WASTE MANAGEMENT FACILITY AT DDE ATTARD LTD, LUQA

VOLUME 3: RESPONSE TO FEEDBACK ON IPPC APPLICATION

Version 3: April 2019

Stage 1: Preliminary activities

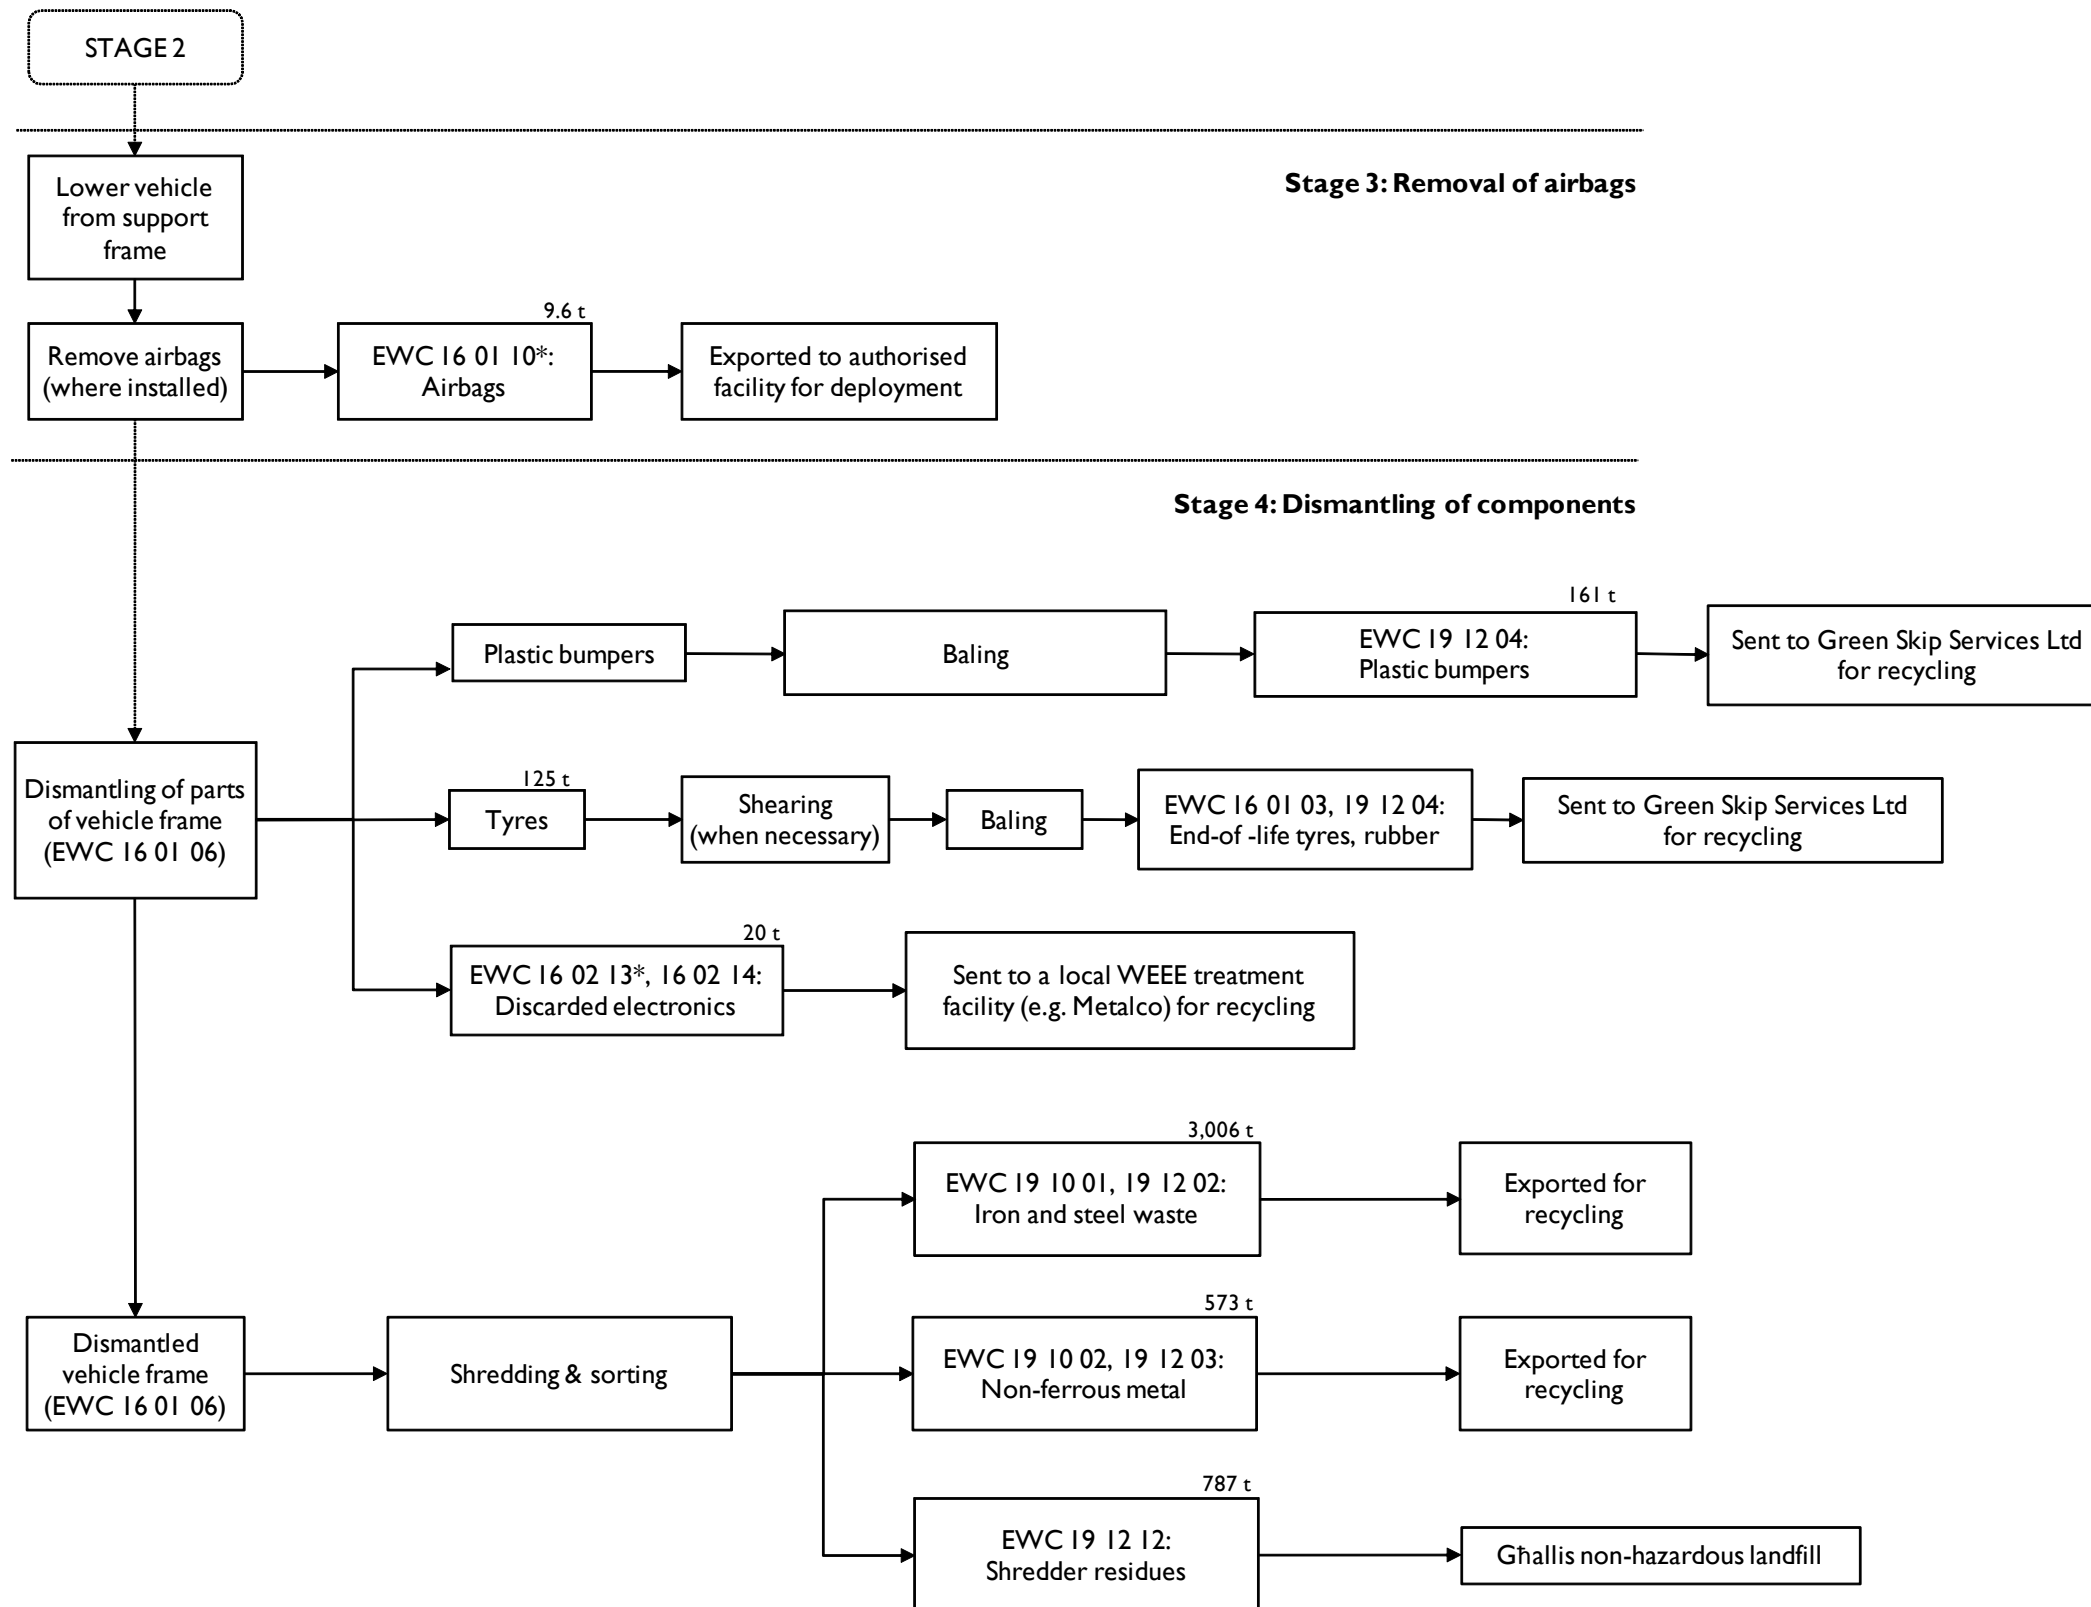
6. Kindly note that Sant'Antnin Waste Treatment Plant is not authorised to accept EWC codes 19 12 04 and 19 12 05 which are indicated to originate from the processing of washing machines, cookers, wood and wire stripping. With regards to wood processing, applicant is to distinguish between wood treated with hazardous substances and that which is not. Any processed waste which shall be sold as a product (e.g. wood for use in fireplaces, compost) is to be covered by an End-of-Waste Certificate. Kindly find attached End-of-Waste application form and contact the Waste Team at ERA on georgesam.mizzi@era.org.mt for further assistance	Noted. The receiving waste management facility permits will be checked before transfers of waste, and when required alternative authorised waste management facilities will be used. Noted.	Alternative permitted facilities or waste broker permits are to be immediately suggested to dispose of such wastes. Flow diagrams are to be updated accordingly. End-of-Waste applications are to be submitted immediately to the Environmental Permitting Unit as part of the IPPC application.	Green Skip Services Ltd will be used; this is permitted by IP 0001/12/A for this EWC code ² . However, as mentioned, alternative licensed facilities will be used during operation of the Scheme as the need arises. The applicant has decided not to pursue the sale of shredded wood. This will instead be sent to the Ta' Żwejra or Ghallis non-hazardous engineered waste facilities (permitted by IP 0001/05/B and IP 0001/06/B respectively). Updated flow diagrams for these processes are included in Attachment 4 .

Composter:

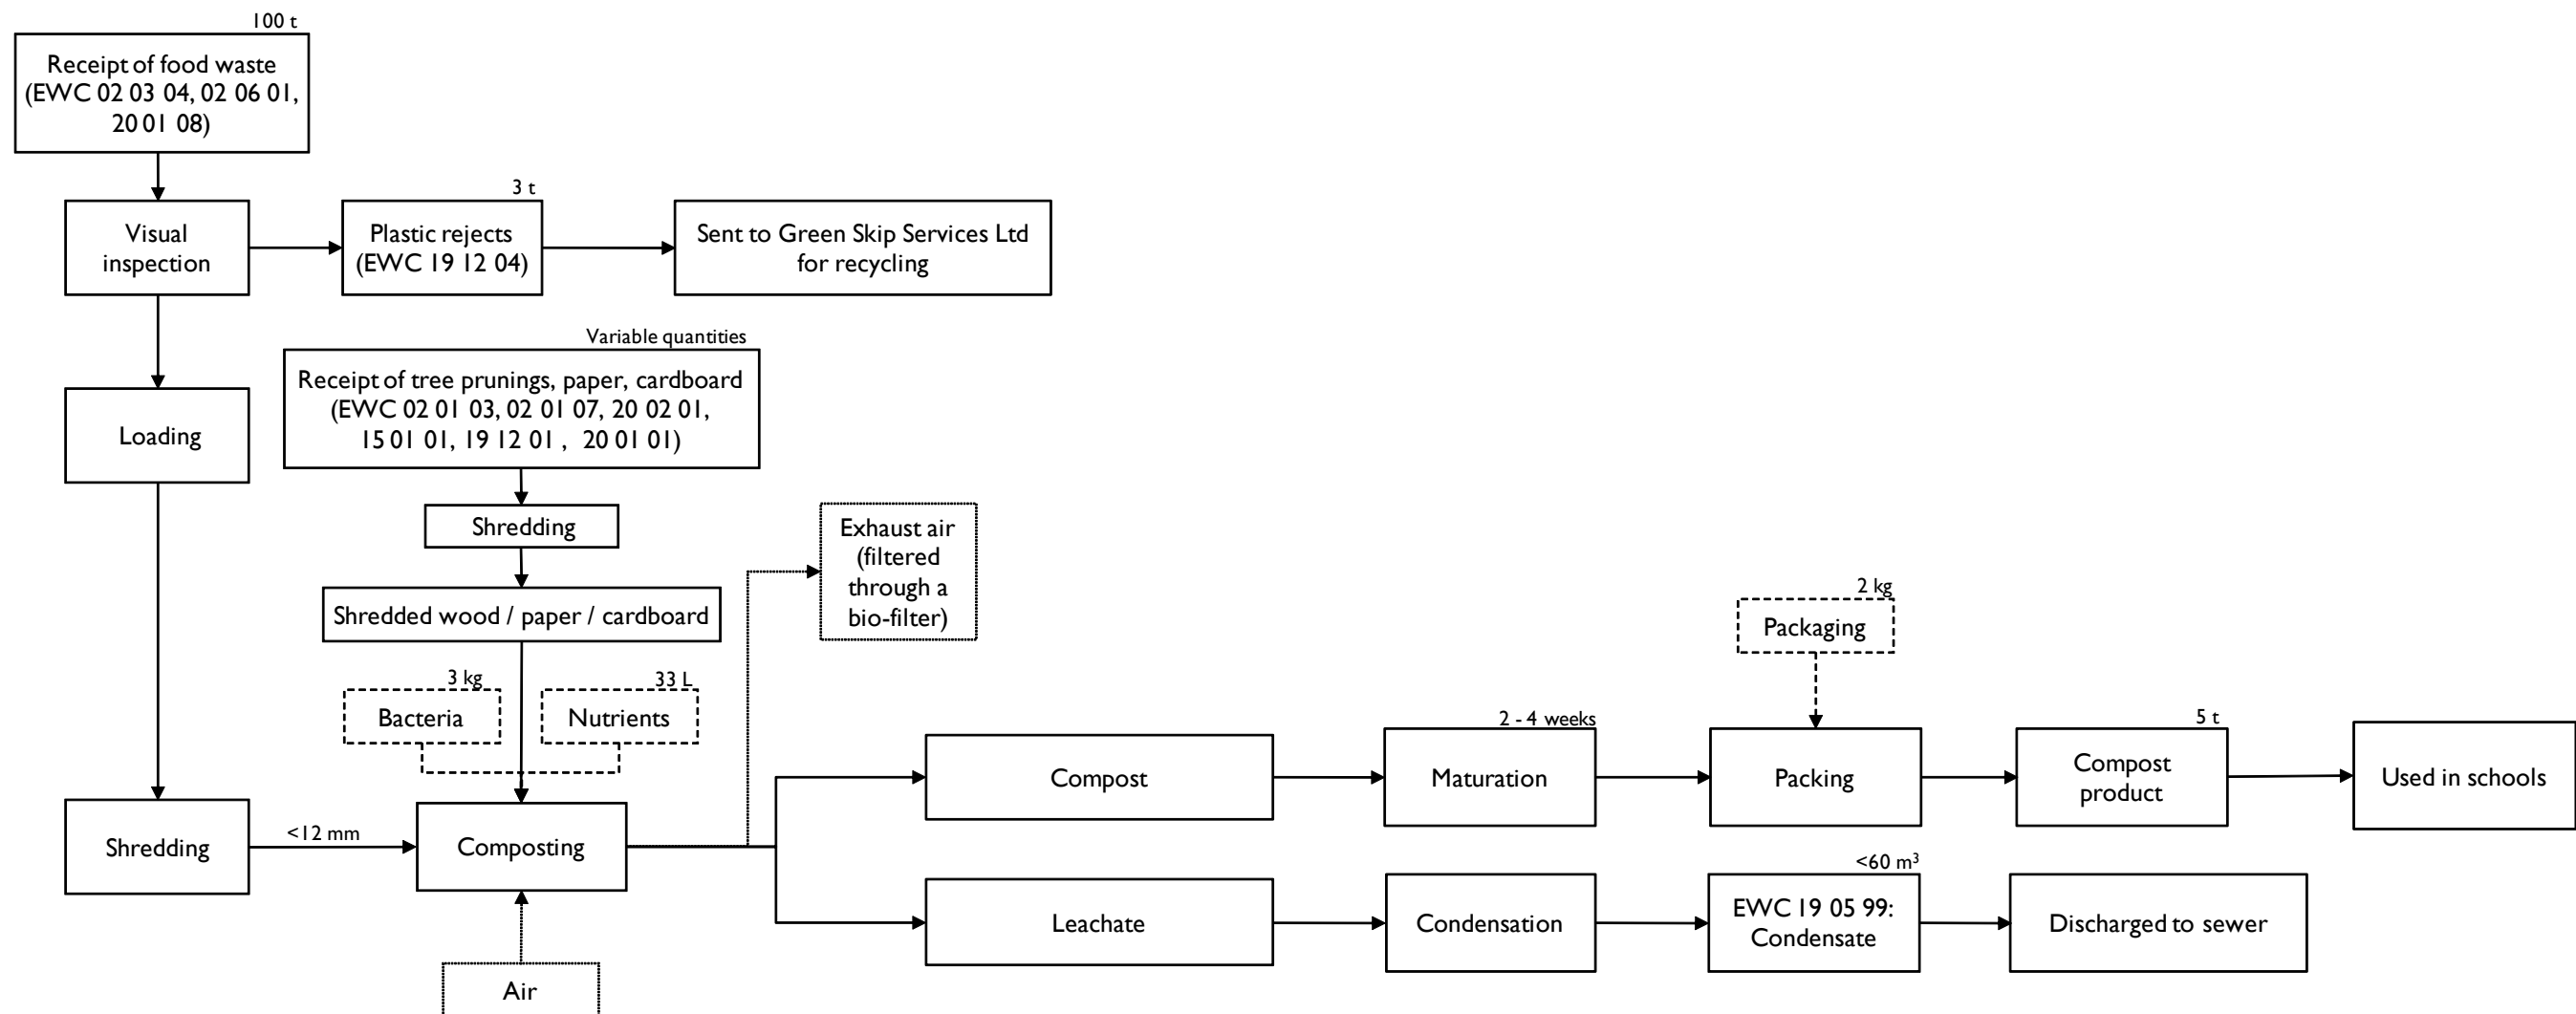
Comment received from	Feedback	ERA reply and comment	Applicant response (1 st October 2018)
	<p>6. In Figure 3.30 Composting flow diagram, plastic rejects are given the wrong EWC code. The code quoted is EWC 19 12 05 refers to glass. Correct EWC code should be 19 12 04.</p> <p>7. Furthermore, applicant is to note that the quoted <i>Commission proposal to establish End-of-waste criteria for biodegradable waste subjected to biological treatment</i> is guidance and as per provisions of regulation 6 of S.L. 549.63 – the Waste regulations, the competent authority shall decide on a case by case basis whether a certain waste has ceased to be a waste.</p> <p>8. <i>Risks and mitigation measures</i> As identified in Table 2.1, it must be ensured that planned mitigation measures are carried out to avoid identified risks, since without these measures, associated risks would be quite high especially the impermeable hardstanding.</p>	<p>6. Applicant is to revise EWC code accordingly.</p> <p>7. Operator to take note of comment.</p> <p>8. Operator to take note of comment. Implementation of such measures will be verified through the necessary compliance procedures.</p>	<p>Attachment 2).</p> <p>6. This has been corrected in Attachment 4.</p> <p>7. Noted.</p> <p>8. Noted.</p>

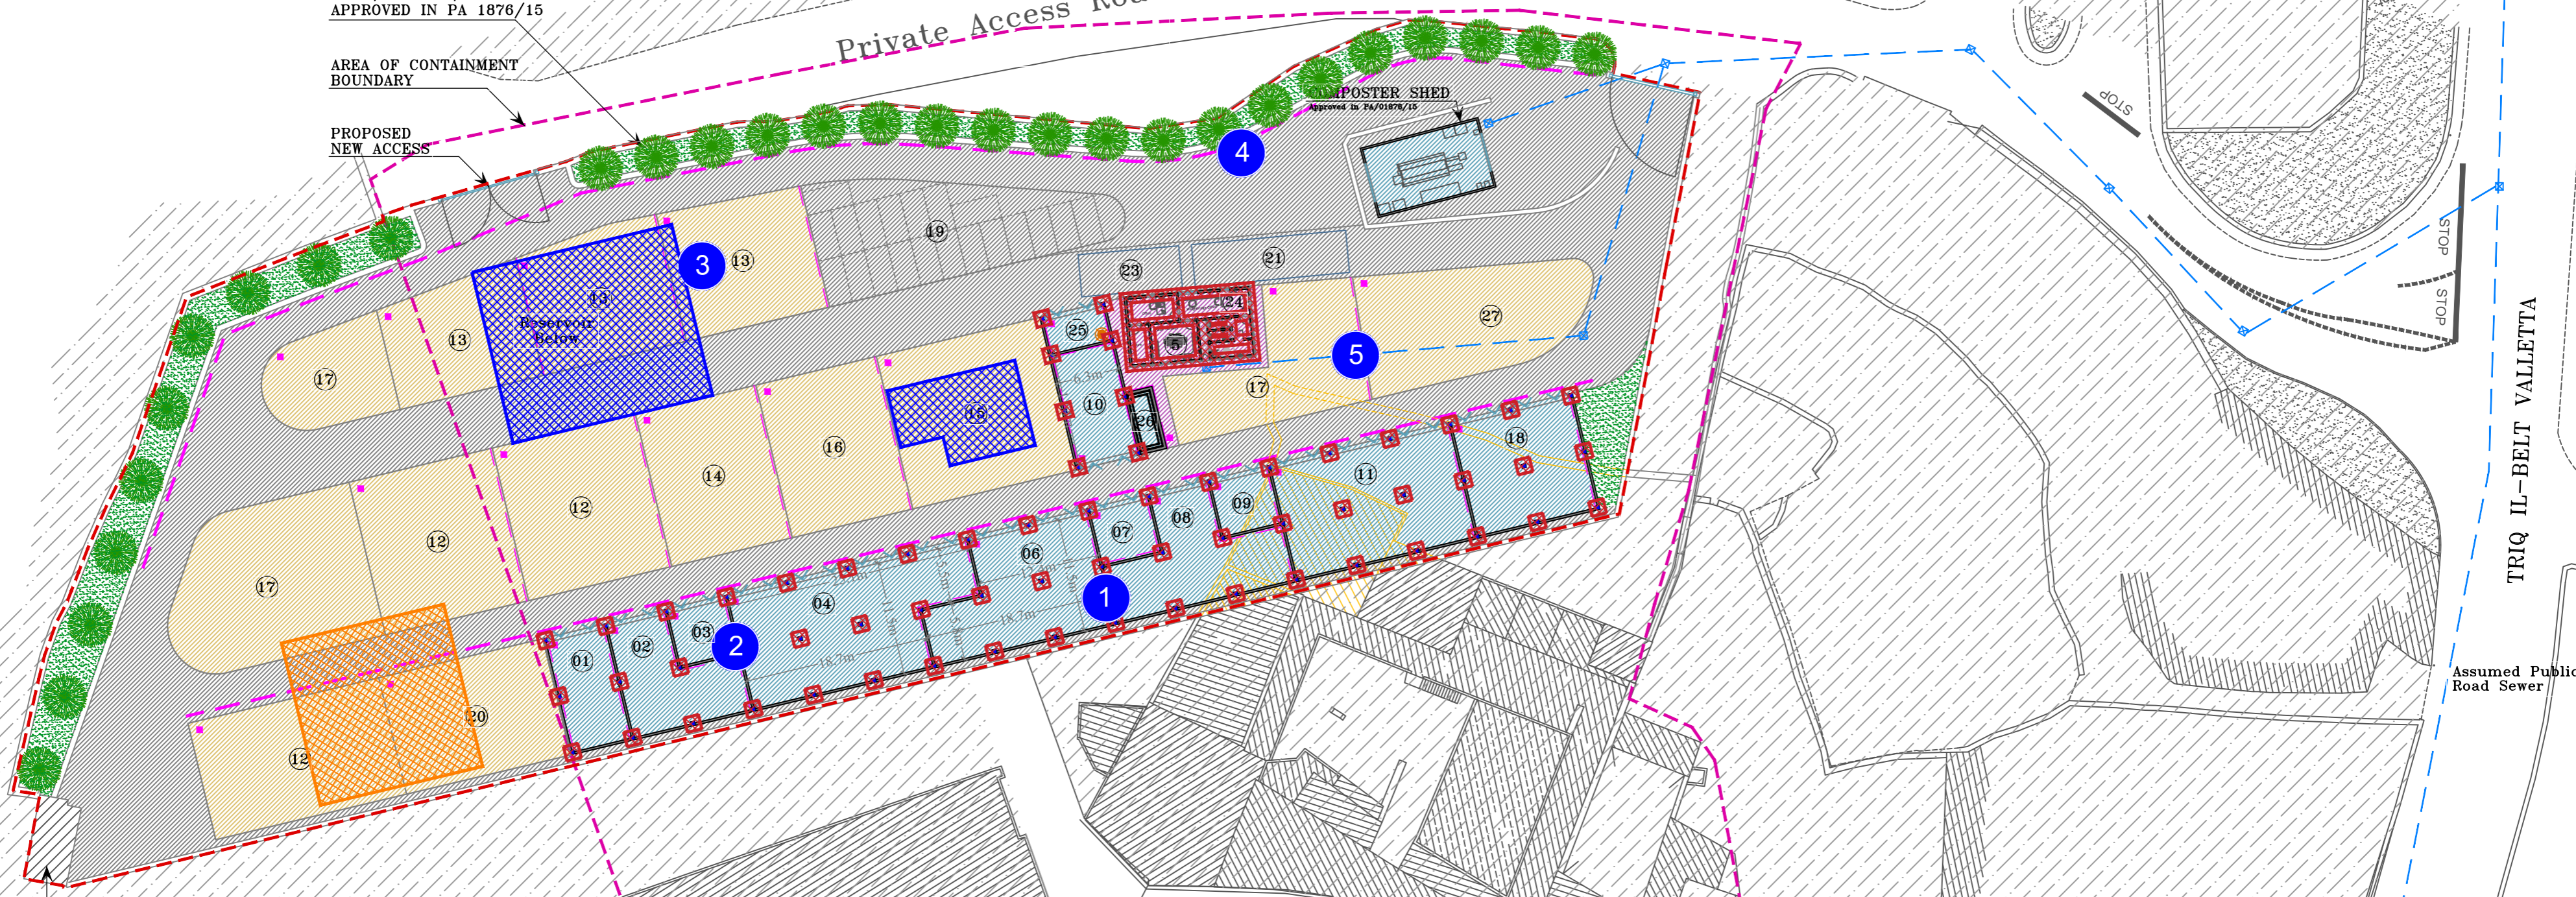
Section	Duly made	ERA comments (16 th February 2017)	Applicant response (9 th October 2017)	ERA comments (12 th February 2018)	Applicant response (1 st October 2018, updated on 1 st April 2019)
		<p>2. With regards to the results of the site investigation report, it appears that the top 1 meter of soil from the whole proposed site is contaminated by heavy hydrocarbons, heavy metals and PCBs and therefore any excavation waste cannot be retained on site. Therefore applicant is to suggest appropriate disposal and/or remediation options for ERA's approval.</p>	<p>The construction of the underground reservoirs necessitates the excavation of <i>circa</i> 1,877 m³ for the storm-water reservoir, and <i>circa</i> 308 m³ for the fire-fighting reservoir. This volume of excavated material will be retained on site and also used for site levelling and earthworks.</p> <p>2. Please refer to the previous point.</p>	<p>solidification/stabilisation of the excavated contaminated material shall ensure that the treated fill/soil material achieves end of waste</p> <p>status in accordance with the legal provisions of Regulation 6 of the S.L. 549.63 – the Waste Regulations and should be accompanied by the “End-of-waste Criteria declaration” found in Schedule 10 of the abovementioned Regulations.</p> <p>II. In order to achieve I. above ERA requires an assessment/description of pre-treatment requirements, suitable reagents and additives for dealing with the relevant contaminants, potential processes (ex-situ) and type of plant and equipment used for the solidification/stabilisation process shall be carried out prior to the commencement of the excavation/remediation works.</p> <p>b. details for sampling and bench-scale testing of the cement stabilized site material.</p> <p>Bench-scale tests are to be carried out prior to the commencement of the excavation/remediation works in order to evaluate the efficacy of various binder formulations using representative samples from the site:</p> <p>Number of representative samples proposed should reflect the level of contamination found in an area, i.e. areas which have higher contamination levels should have a higher frequency of samples. (<i>for example the area near sampling point 2 (southern part) is to be sampled with higher frequency since it is highly contaminated</i>)</p> <ul style="list-style-type: none"> • assessing whether any pre-treatment steps are necessary (screening to remove material over a particular size, processing to re-grade the particle size distribution of the material); • assessing the ability of potential mixes to achieve remedial criteria with regard to leaching and physical characteristics (e.g. strength, permeability); • identifying the potential for volatile emissions during works; • assessing the physical and chemical uniformity of the treated material; • determining the likely volume increase associated with the treatment; and • assessing the long-term performance of the treated material. <p>It is important that the samples prepared for</p>	<p>waste management facilities. In view of this the excavation / fill drawing in Attachment 5 has been updated.</p>
